Docket Item# 3
BAR CASE #2011-0101

BAR Meeting
June 1, 2011

ISSUE: Certificate of Appropriateness for Alterations
Waiver of HVAC Screening Requirement per Section 6-403(B)

LOCATION: 610 King Street

Figure 8: Roof Plan

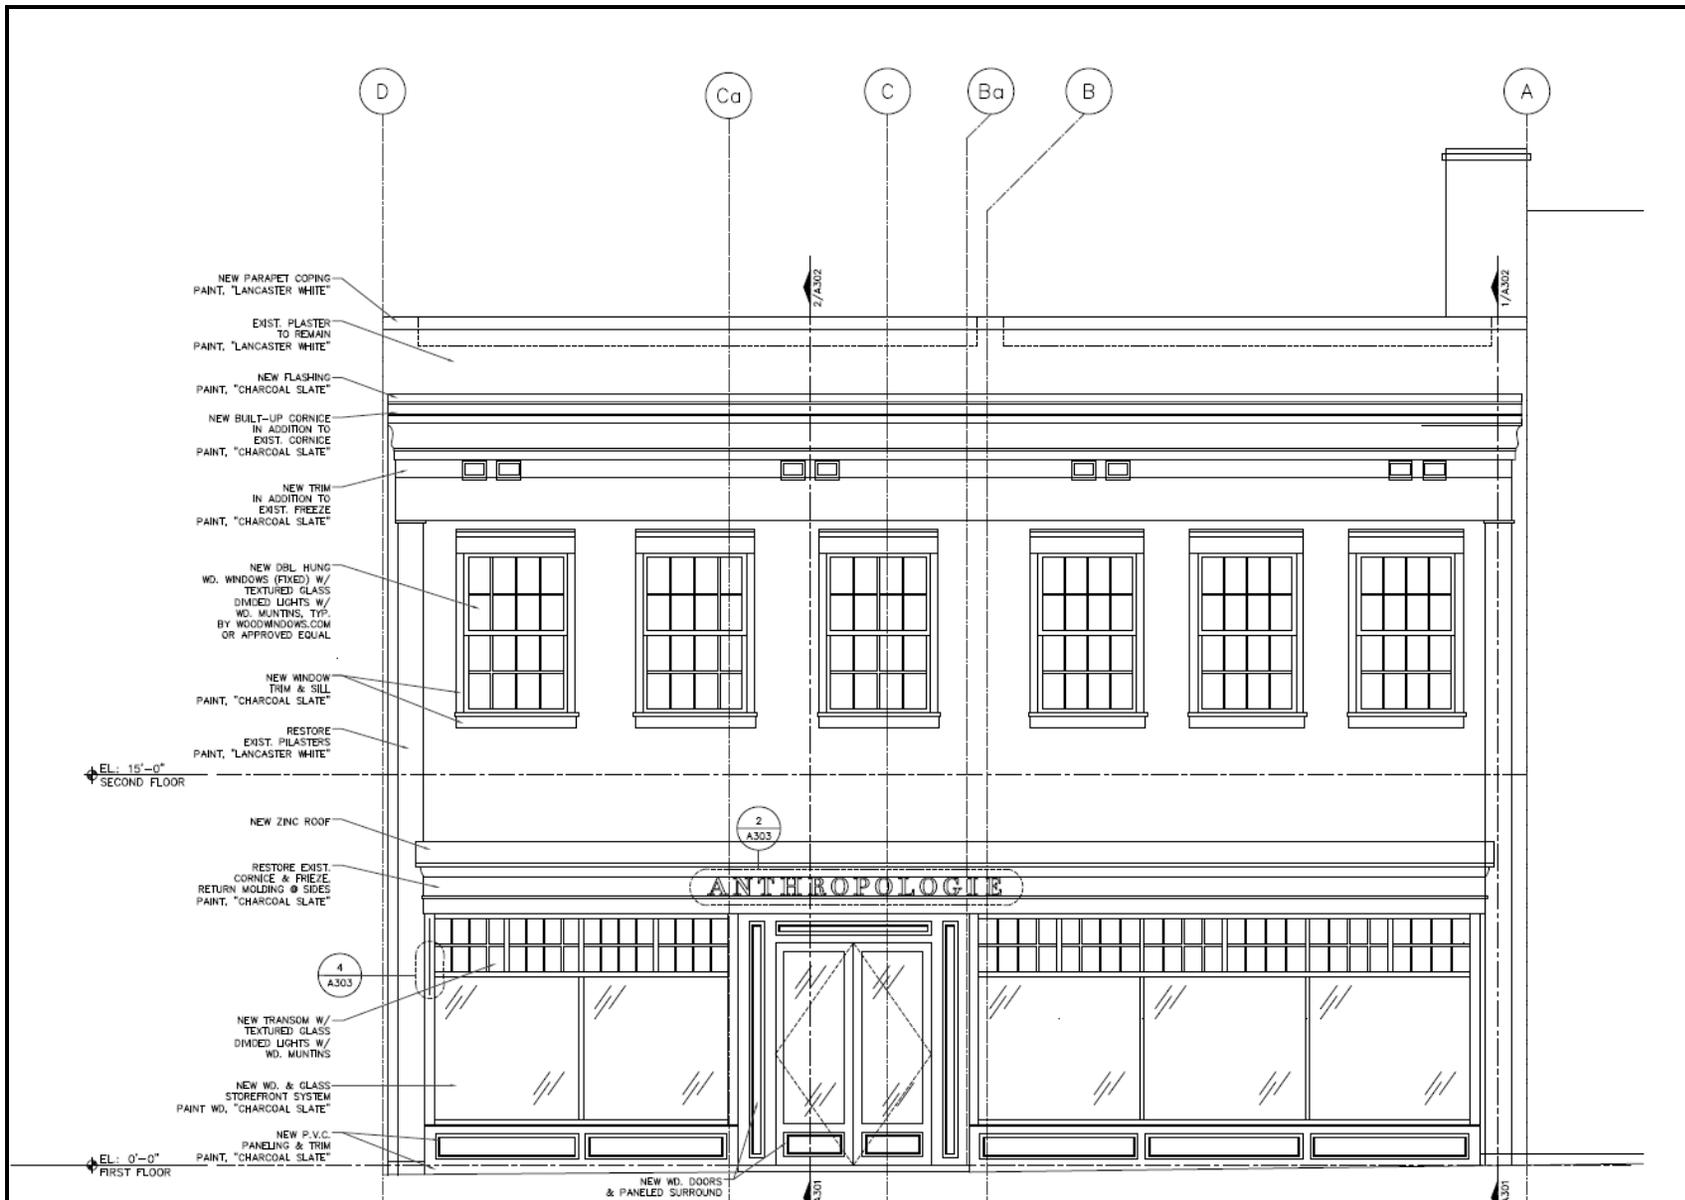
The applicant is proposing to install an elevator penthouse and HVAC equipment on the existing roof. Due to the proposed location, in the center of the roof and the building’s existing parapets, the new, elevator penthouse and HVAC equipment will not be visible from the public ROW.

Staff recommends that the Board find that the HVAC units would not be visible by pedestrians from King Street nor the adjacent rear public alley and that they are adequately screened by the existing parapet walls. Installing HVAC equipment on the rooftop is architecturally appropriate, consistent with the character of the district and is common on surrounding buildings. Staff recommends that the Board support the waiver of Section 6-403(B)(1) HVAC screening requirement.

Figure 10: Proposed West Elevation

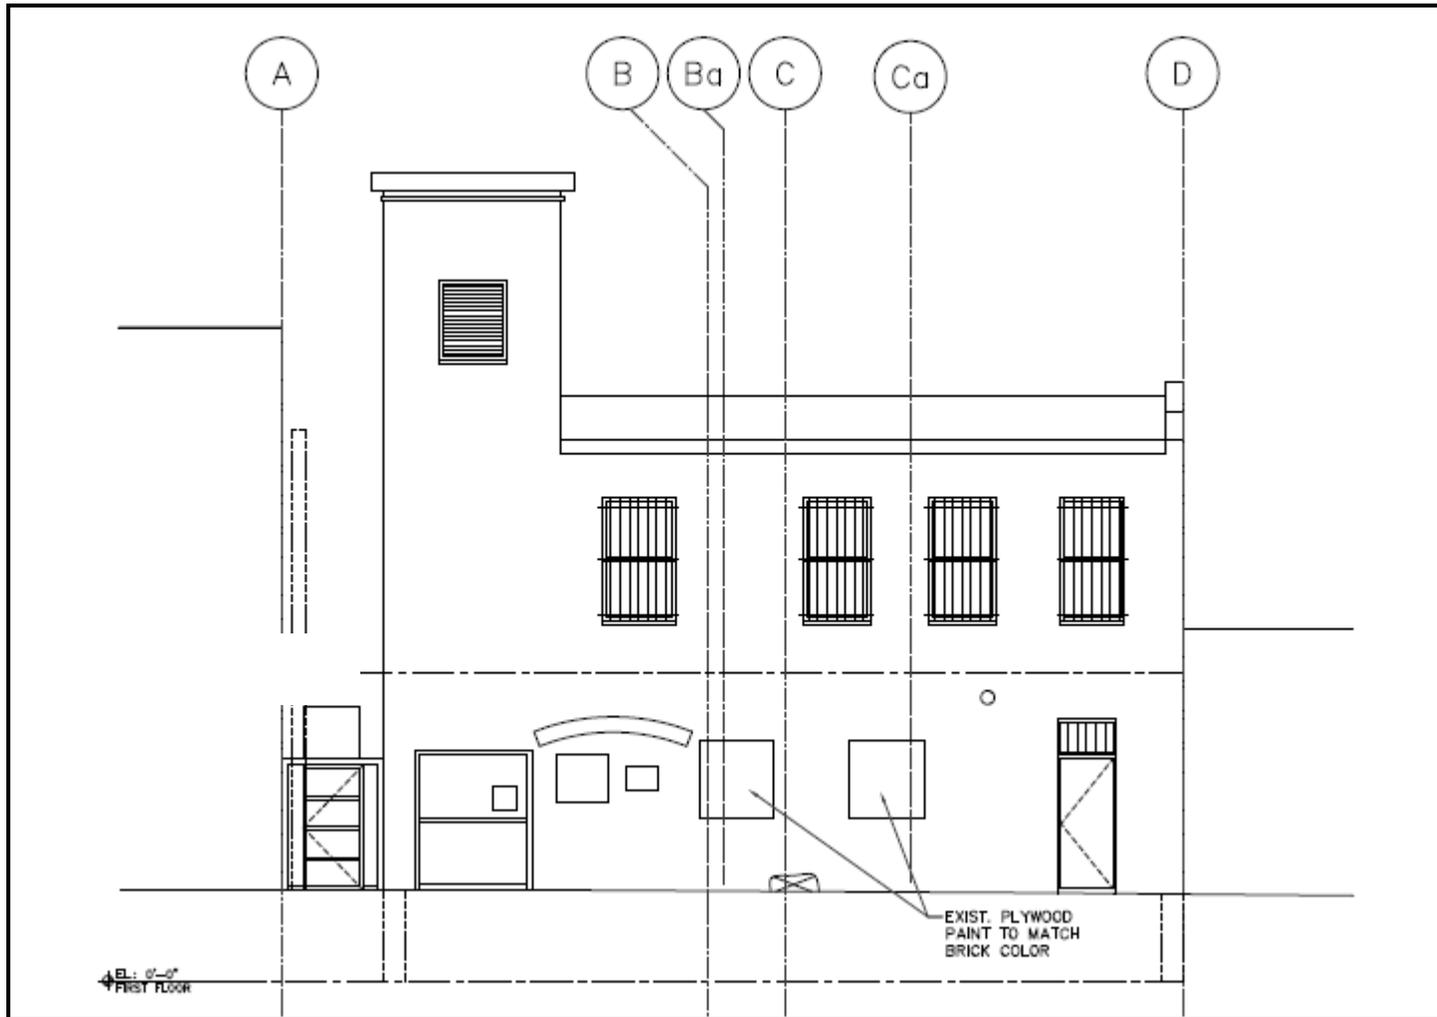
The windows to be enclosed on the west elevation are not visible from a public ROW and are located in an inaccessible service alley. Additionally, the historic window sashes have already been removed and the proposal will be retaining the window’s rough openings and brick arches. Since the in-filled windows could be reversed in the future, Staff does not object to the alterations and notes that the CMU block will be recessed from the face of the surrounding wall.

C-4 Applicant shall show the use of the space(s) affected by the infill of the two window openings on the west alley. Light and ventilation will be required to be achieved mechanically

Figure 12: Proposed Storefront Details

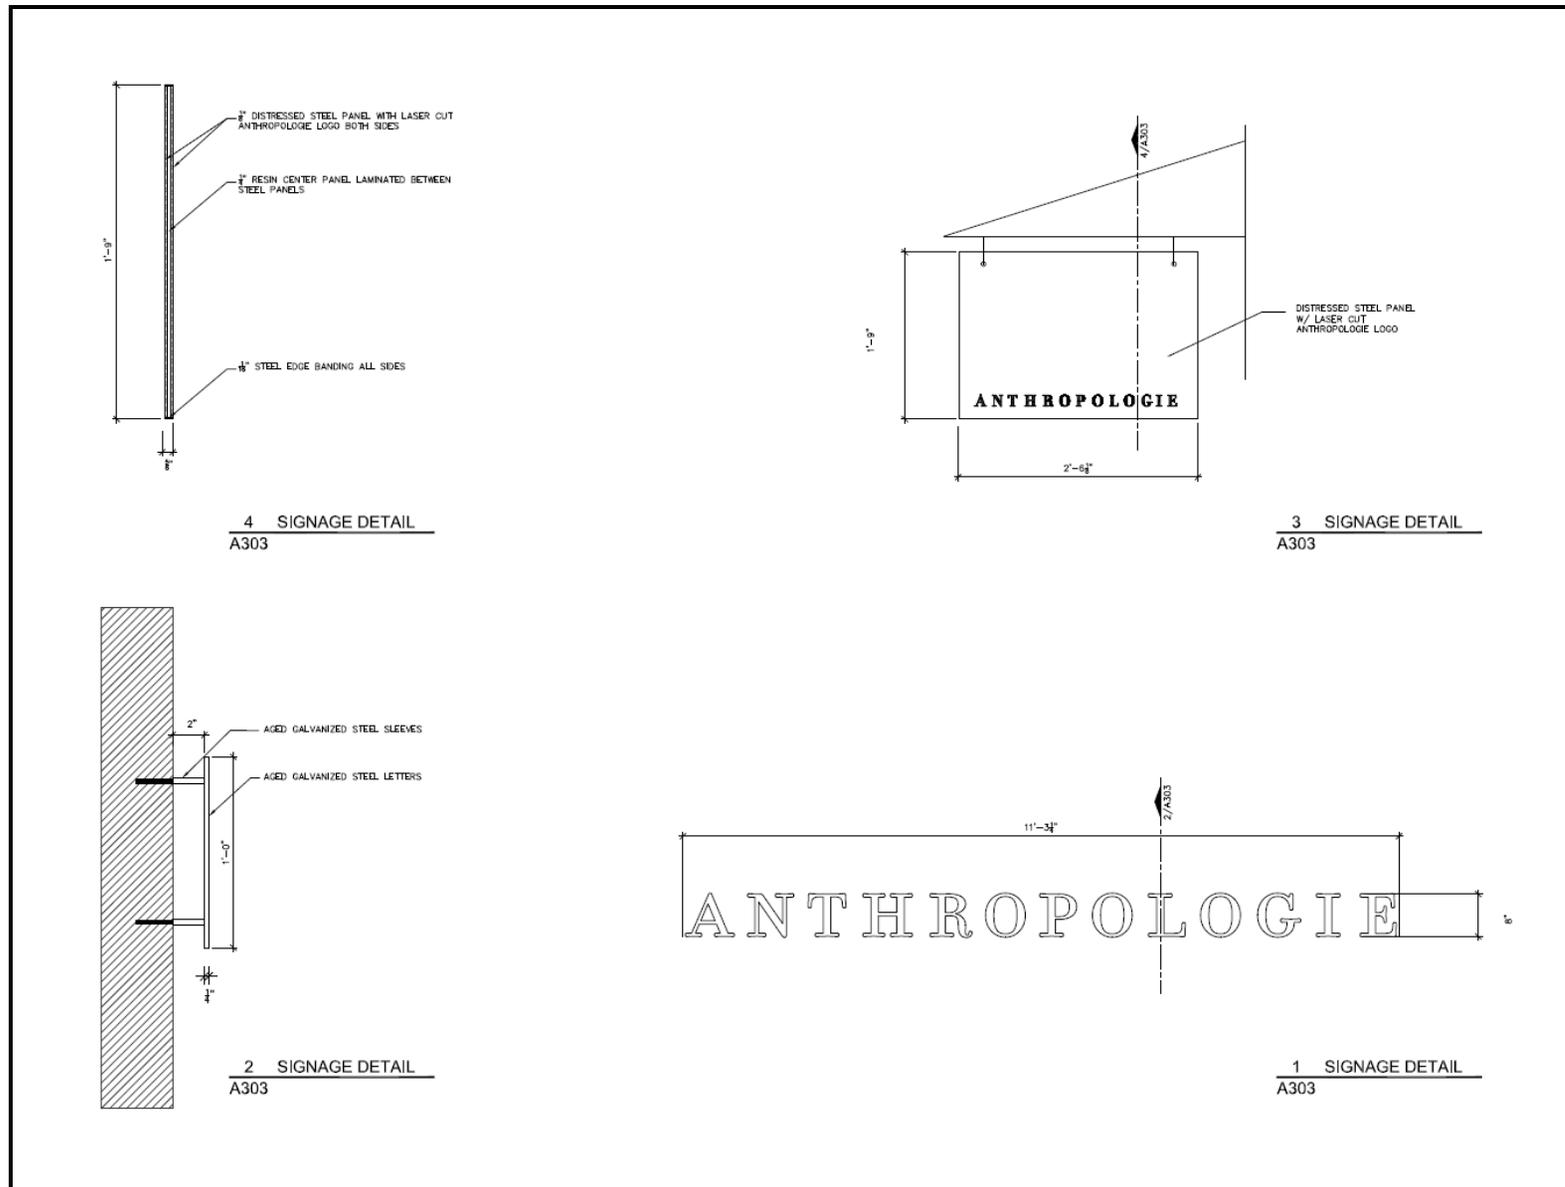
Based on research of past BAR approvals, Staff does not believe that any of the existing windows are historic. The applicant is proposing to replace the existing 1/1, double hung sash windows on the south façade with 6/6 sash to reflect the building's late 19th/early 20th century period of construction. The storefront previously approved by the Board will remain generally intact. However, the existing plate glass windows will be replaced with a new storefront designed in the Colonial Revival style with paneled bulkheads, multi-light painted-wood glazing, and single-light, paired entry doors surrounded by painted-wood panels. All of the proposed details are compatible with the original architectural style.

The new windows on the second-story and in the storefront transoms will contain textured glass. The applicant desires to utilize this material for privacy in the second floor fitting rooms as well

as to simulate an antique hand blown “cylinder glass” appearance in the storefront transoms. The use of art glass in the upper portion of storefront windows was common in the late 19th and early 20th century. Since the windows will be replacements and the glass will only be noticeably visible in the storefront transom, Staff supports its use.

Figure 13: Proposed Signage

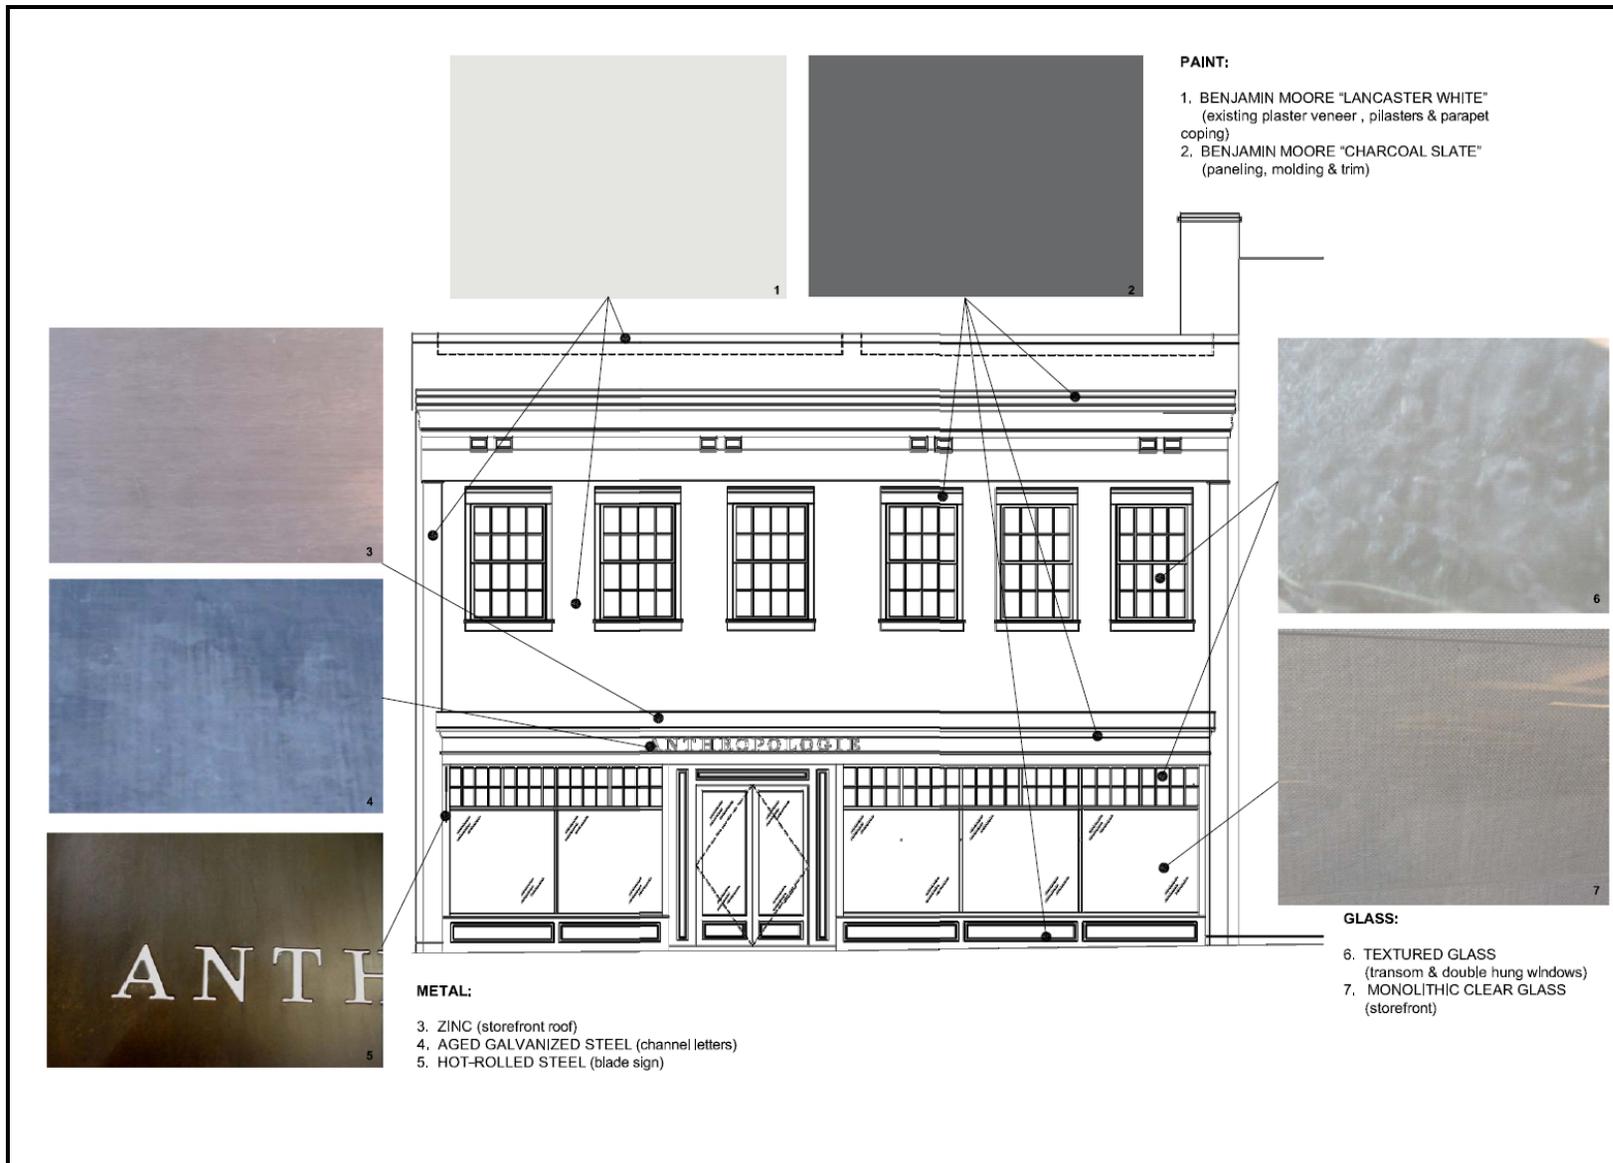
The *Design Guidelines* recommend that one sign per business is generally appropriate. However, the Board has frequently approved more than one sign for a business with a single frontage. The signage typically is a combination of projecting hanging, wall mounted lettering and/or window decals. Due to the large storefront’s location on King Street, and the types of

signs approved for nearby businesses of similar scale, staff believes that two signs are appropriate for this business.

According to the *Design Guidelines*, “Signs and awnings are prominent visual elements of the streetscape in commercial areas of the historic district;” furthermore, “Signs should blend with and not detract from the historic architecture of the district.” Staff finds that the proposed signage consistent with the *Design Guidelines* and is appropriate in design, material and scale to both the architectural character of 610 King Street and this section of the historic district.

- C-3 A sign may be erected or displayed flat against a building wall or at an angle thereto, so long as the sign does not project more than four feet from the building wall or within one foot of an established curb line and the bottom of the sign is at least eight feet above a sidewalk or parking area and at least 14.5 feet above any alley. (Sec. 5-2-29(c)) (T&ES)
